CITY of NOVI CITY COUNCIL

Agenda Item K
June 16, 2014

SUBJECT: Approval of a request from Interphase Land Development for a variance from the following ordinance sections for the Casa Loma residential development: 1) Section 11-68(a)(1) requiring a minimum of two points of connection for a water main that exceeds 800 feet from a looped source, and 2) Section 11-194(a)(7) regarding the configuration of the proposed cul-de-sac.

CASA LOMA

FIGURE IX.3

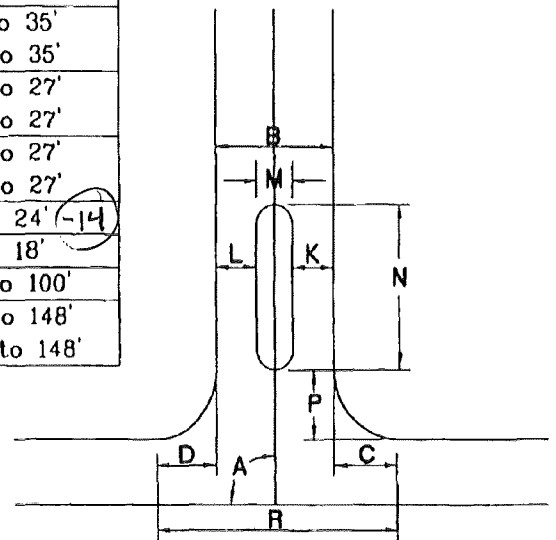
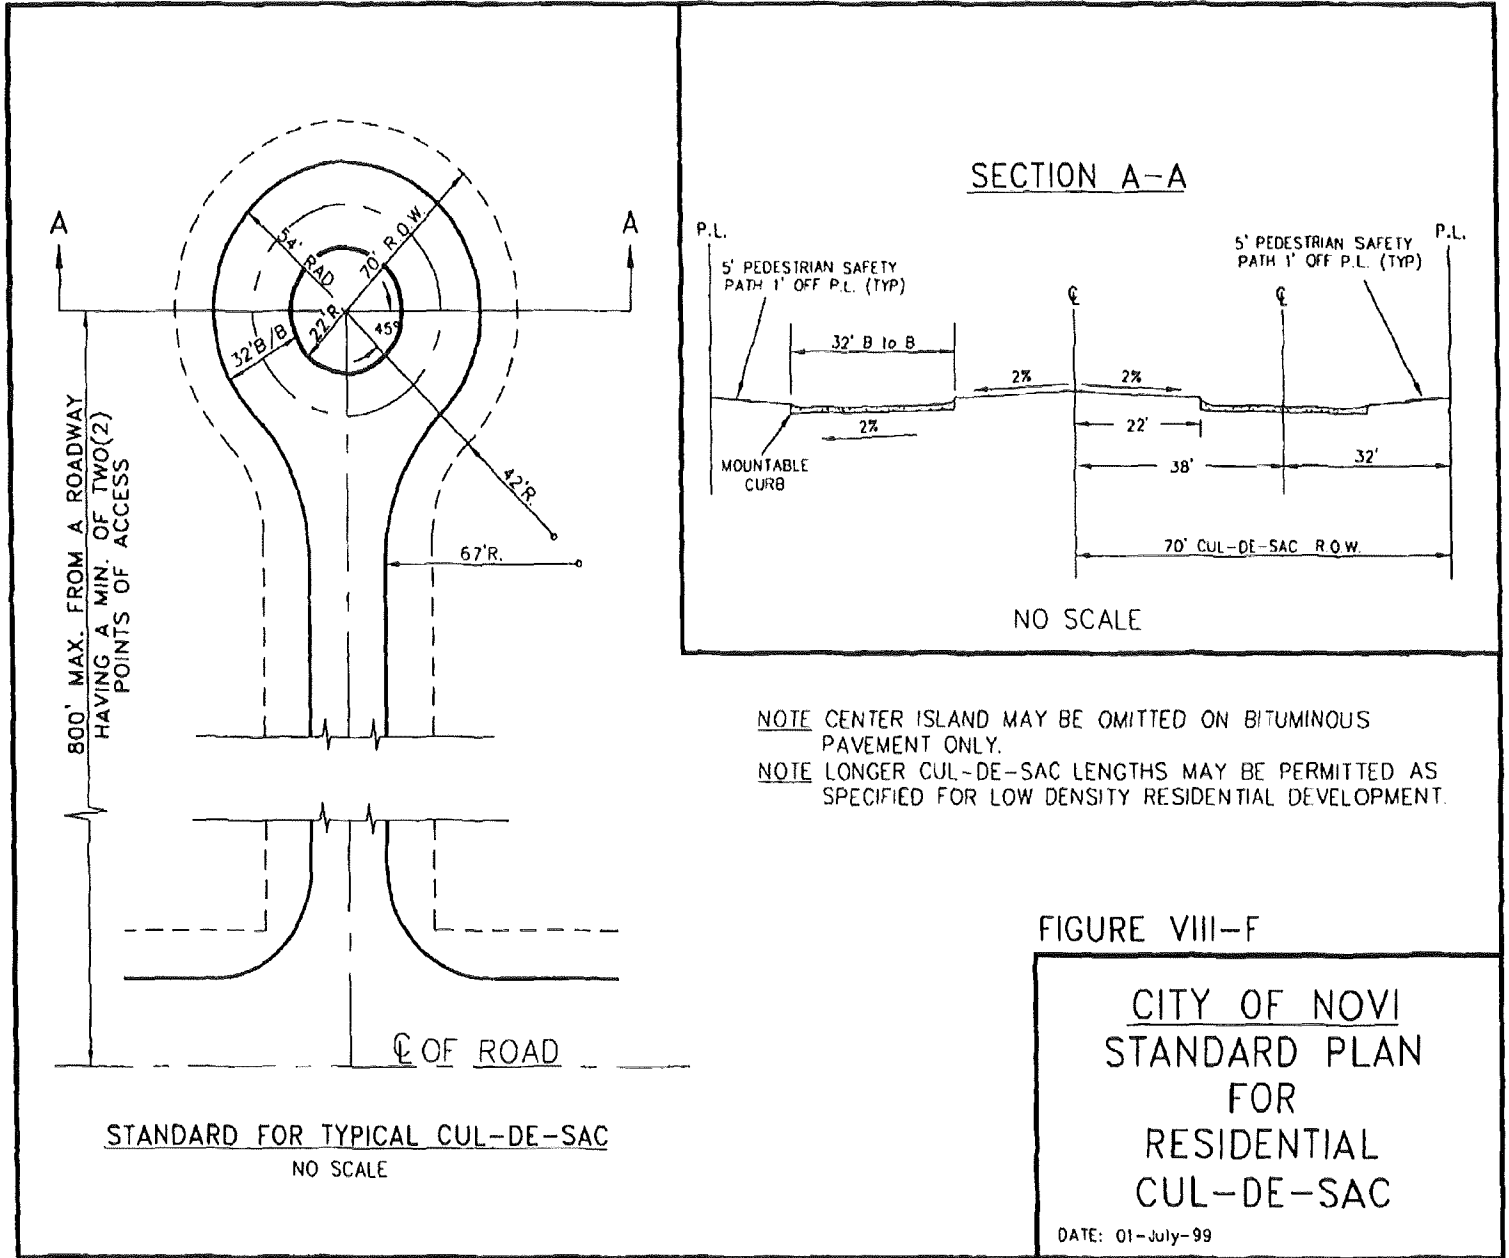
- 2) Design and Construction Standards, Article IX. Drive Approaches, Turn Lanes, and Passing Lanes, Figure IX.3 (shown below) provides a drive with range of 22' to 27'. The proposed drive width is 22 ft, falling within this range.

PROJECT NO: 11500089
C-401
SHEET NO: 6 OF 8
© 2011 Nederveld LLC

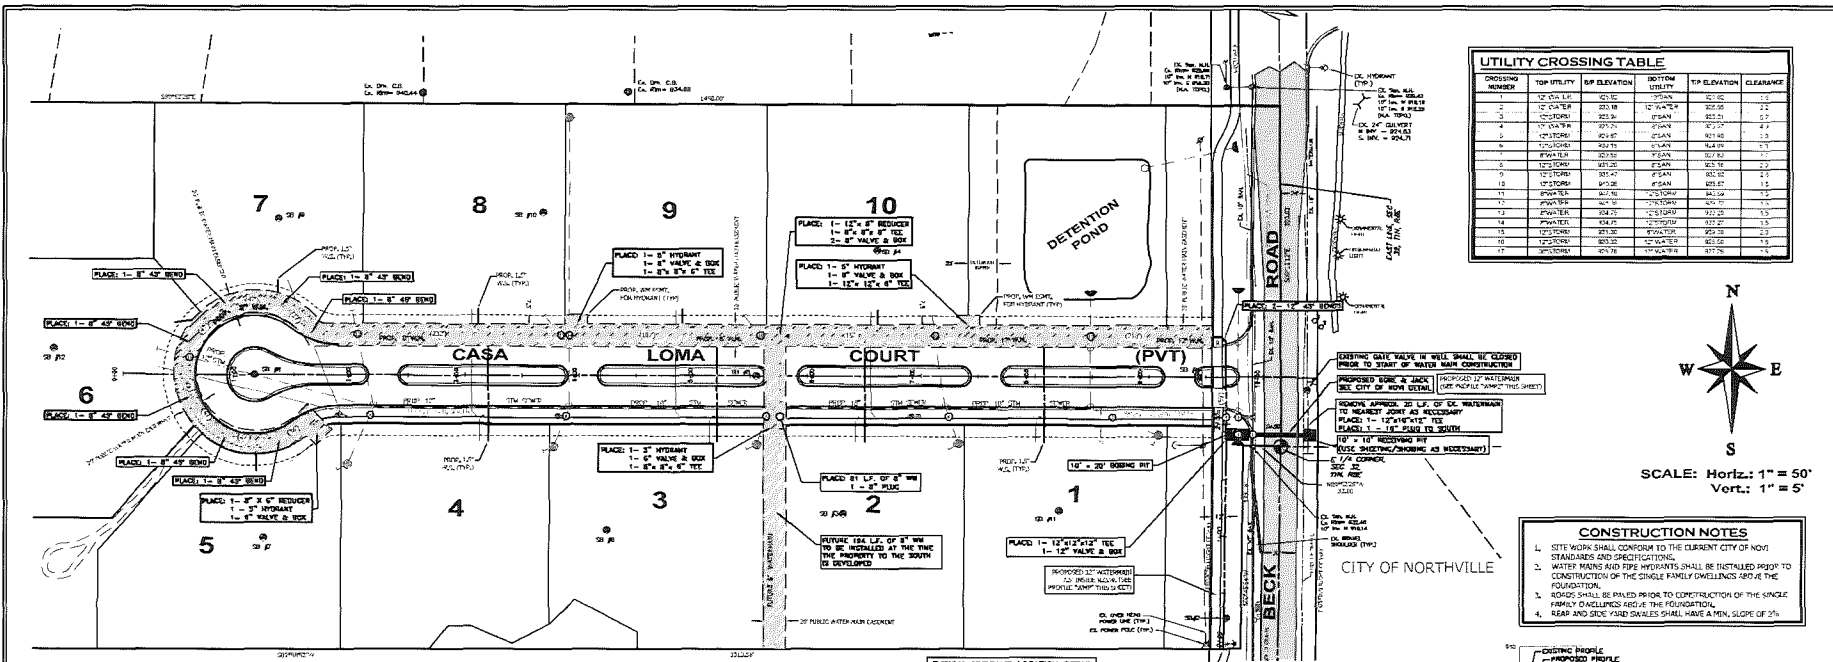
In an effort to accommodate the City’s request of a looped connection, an 8” water main stub and easement is proposed between Lots 2 and 3 to the south property line. This proposed stub and easement will allow for a future water main connection to the south when the south parcel is developed.

The owner is requesting to defer construction of the water main stub to the south property line, provide an easement for the possible future water main, and form an agreement with the City that states that the Homeowners Association will pay for the cost of the water main stub if the water main stub is ever extended in the future. This will be written into the Master Deed and Bylaws.

- 1) The proposed water distribution system provides all 10 lots within the Casa Loma development with the required 2,000 gpm at 20 psi. Water pressure and volume will not be an issue and the stub is not required to get adequate water. Refer to Water Distribution System Model.
- 2) The project is adjacent to woodland and wetland. Not requiring a stub at this time will save trees and vegetation.

- 3) The difference in length between what is allowed (800 ft) and what is proposed (990 ft) is relatively minor (190 ft). The length that is proposed is not excessively above the 800 ft that is allowed without a variance.

- 4) Due to the size and number of lots to the south of the Casa Loma development, it is our opinion that it is unlikely that this area will ever be developed as a subdivision. Therefore, it is our opinion that the water main loop will not be constructed in the future, regardless of whether or not a stub is provided to the south property line.

- 5) The developer will provide a water main easement between Lots 2 and 3 to provide for future construction of a water main loop to the south if the land to the south is ever developed and if the water main loop is deemed beneficial in the future. Therefore, provisions will be made to provide the loop in the future if needed.

- 6) The deferred construction will keep water main from being located in close proximity to the houses on Lots 2 and 3. If the line is installed and a break occurred in that line, the houses on those lots would likely be damaged.

- 7) The deferred construction will reduce the length of “dead end” pipe and will reduce stagnant water in the water main stub.

I discussed with the project owner and the water main stub to the south property line will be constructed by the developer during site construction. The plans will be modified accordingly.

FIGURE VIII-F

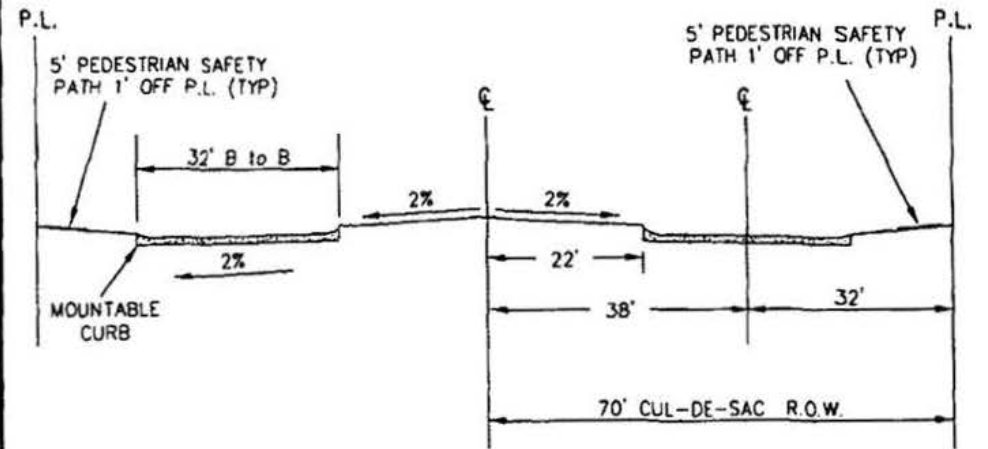
Overview: The Casa Loma development is a 10 lot, single family residential site condominium development on the west side of Beck Road, just south of Belagio. The proposed project will be serviced by a private, gated, boulevard cul-de-sac connecting to Beck Road. The proposed boulevard will have 22 ft wide driveways adjacent to a 14 ft wide landscaped island. The proposed boulevard section will run the entire length of the proposed cul-de-sac, with openings for cross driveway traffic, and terminate into the center island at the end of the cul-de-sac.

The justification for allowing the 22 ft wide driveway width and boulevard cul-de-sac geometry is as follows.

- 3) Article VIII Sec. 11-194 (a) (7) states that "cul-de-sac shall be designed in accordance with Figures VIII-F." Figures VIII-F (shown below) does not take into account boulevard cul-de-sacs, therefore we request

- Section 11-194(a)(7) requires cul-de-sacs to be designed with certain dimensions to facilitate movements by emergency vehicles. The developer is proposing a revised geometry for the cul-de-sac that is unique to this development, but does not deviate substantially from the performance derived from the City's standard design, and is not detrimental to public health because the proposed alternative allows movements and access by emergency vehicles. Therefore, staff is recommending approval of this request as well.
